PLANNING COMMISSION MEETING AGENDA REGULAR MEETING

SUBJECT: PRELIMINARY SITE PLAN APPROVAL (JPLN2024-0009) – Proposed Town Haven Site Condominium, 19 units, South of Wattles, West of Rochester (Parcels 88-20-22-226-023 and 88-20-22-226-024), Section 22, Currently Zoned R-1C (One-Family Residential) District.

Preliminary Site Plan Review For City of Troy, Michigan

Project Name:	Town Haven
Plan Date:	April 1, 2024
Location:	934 E Wattles Road
Zoning:	R-1C, One-Family Residential District
Action Requested:	Preliminary Site Plan Review

HALSTON

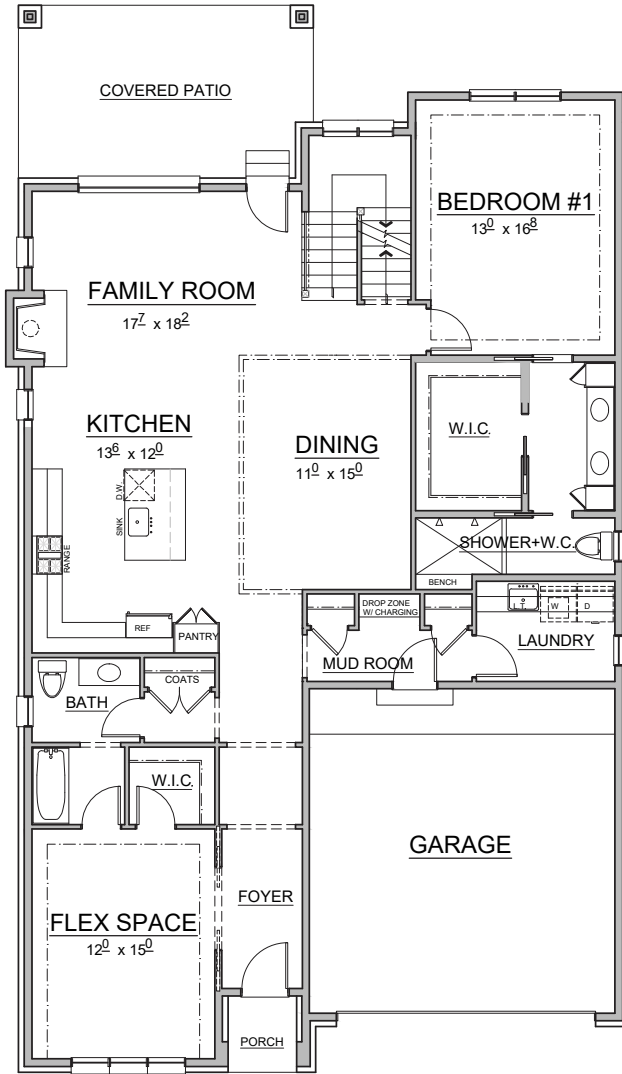
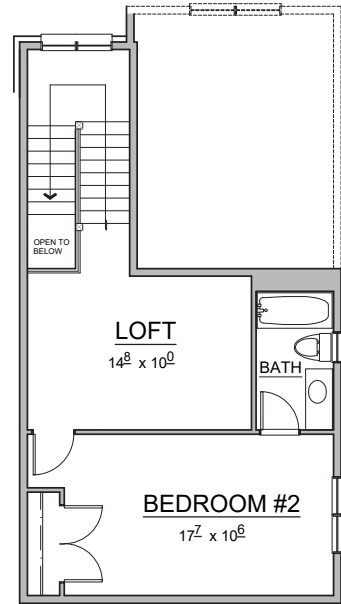
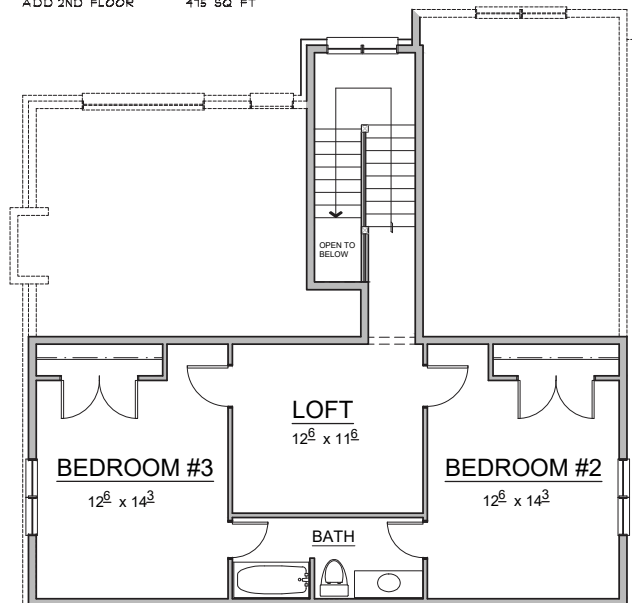
Plans indicate that there are two (2) optional second floor plans for the Halston. Optional second floor plan #1 measures 475 square feet and includes a second bedroom, third restroom, and loft area. Optional second floor plan #2 measures 724 square feet and includes two (2) additional bedrooms, one (1) additional restroom, and loft area.
